1. CENTRETOWN TRAFFIC CALMING PLAN AND KENT STREET TRAFFIC CALMING CONCEPT PLAN

COMMITTEE RECOMMENDATIONS AS AMENDED

Our File/N/Réf. Your File/V/Réf.	50 09-98-0008
DATE	13 February 1998
TO/DEST.	Co-ordinator Transportation Committee
FROM/EXP.	Director Mobility Services and Corporate Fleet Services Environment and Transportation Department
SUBJECT/OBJET	CENTRETOWN TRAFFIC CALMING PLAN AND KENT STREET TRAFFIC CALMING CONCEPT PLAN

Centretown • Kent Street Traffic Calming Plan

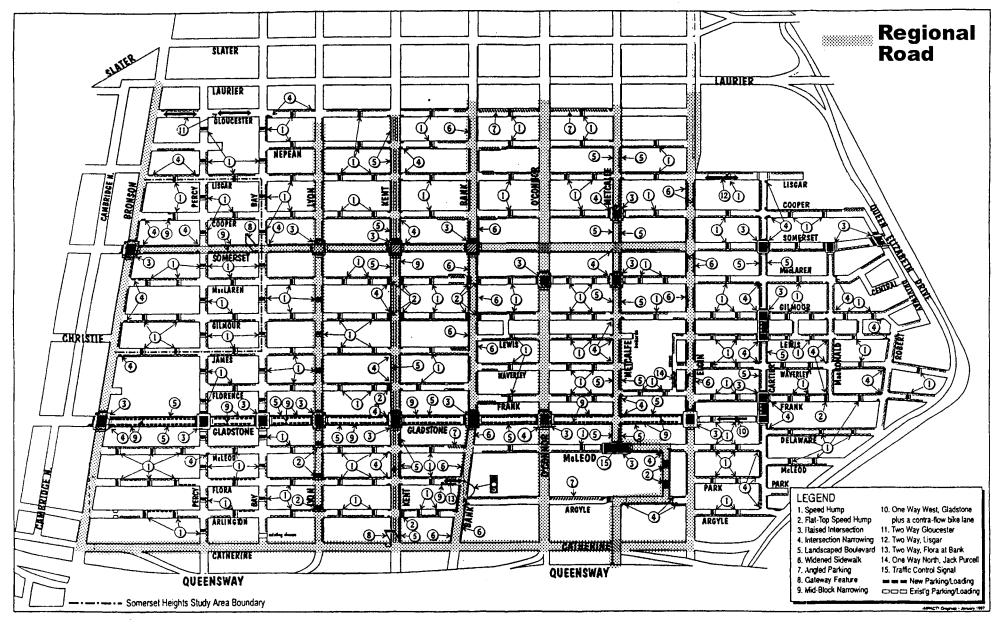
The Kent Street concept plan illustrated in Annex A provides an appropriate and acceptable concept plan to proceed with final design and implementation as priorities and funds dictate. The raised intersections illustrated for the intersections with Somerset Street and Gladstone Avenue are cause for concern on major arterial streets such as Kent Street, since they may have adverse impact on emergency vehicle and bus operations, and will require extra maintenance. These measures should not be implemented until the pilot project for Kirkwood and Churchill Avenues is assessed.

- 2. that, subject to technical evaluation, detailed design, and the identification of capital and operating funds, the *Preferred Kent Street Traffic Calming Concept Plan* as illustrated in Annex A and Figure 5.2 of the consultant's report be approved;
